Item ID: D212-664-101

Item Name: Crosstube Fwd

DRAWING NO. D212-664-141	TITLE XTUBE ASSY (205/212/412 HI FWD)	REV. D	DART AEROSPACE LTD ENGINEERING ORDER		D.E.O. NO. D212-664-141-D-1	SHEET NO. SHEET 1 OF 2	SCALE NTS
DRAWN	CHECKED	MFG. APPR.	APPROVED	DE APPR.			
DATE 11.04.07	DATE 11.04.11	DATE 11.04.12	DATE 11/04/12	DATE 11.04.12

ADD AN INSPECTION WINDOW TO UNDERSIDE OF CROSSTUBE.

**D212-664-141/-141B
ASSEMBLY DETAIL**

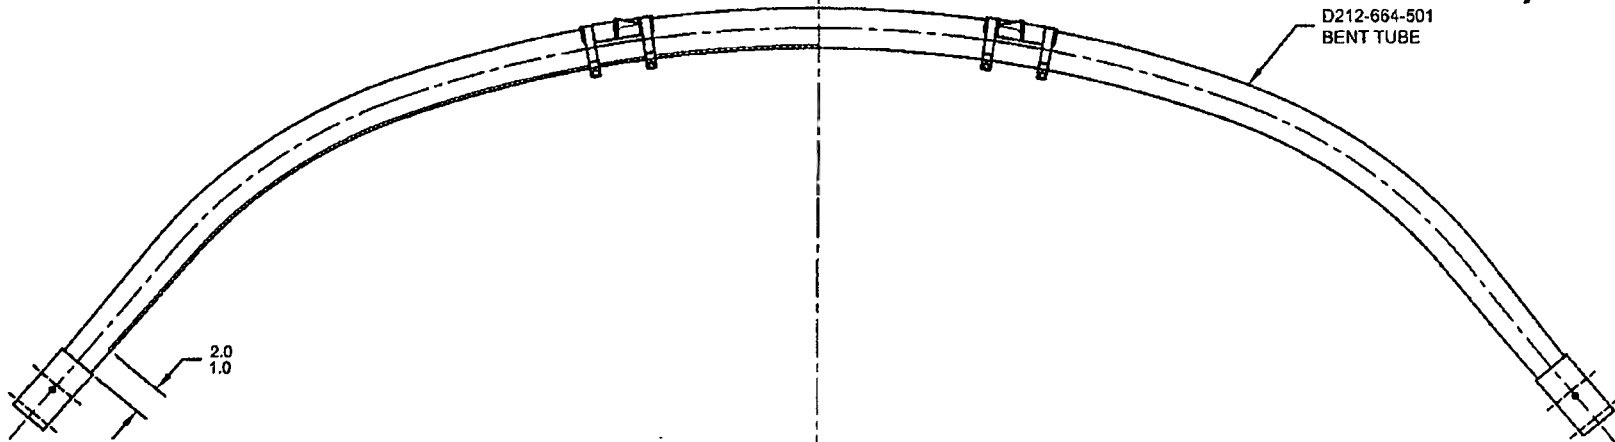
- 2) FINISH: CHEMICAL CONVERSION COAT PER DART QSI 005 4.1
PRIME INSIDE AND OUTSIDE PER DART QSI 005 4.2
MASK UNDERSIDE OF CROSSTUBE AS SHOWN (HATCHED AREA) AND
PAINT OUTSIDE PER DART QSI 005 4.2
REMOVE MASKING AND APPLY CLEAR COAT

- 2) FINISH: CHEMICAL CONVERSION COAT PER DART QSI 005 4.1
PRIME INSIDE AND OUTSIDE PER DART QSI 005 4.2
PAINT OUTSIDE PER DART QSI 005 4.2

MASK AREA PRIOR TO PAINTING,
REMOVE MASKING AFTER PAINT
AND APPLY CLEAR COAT
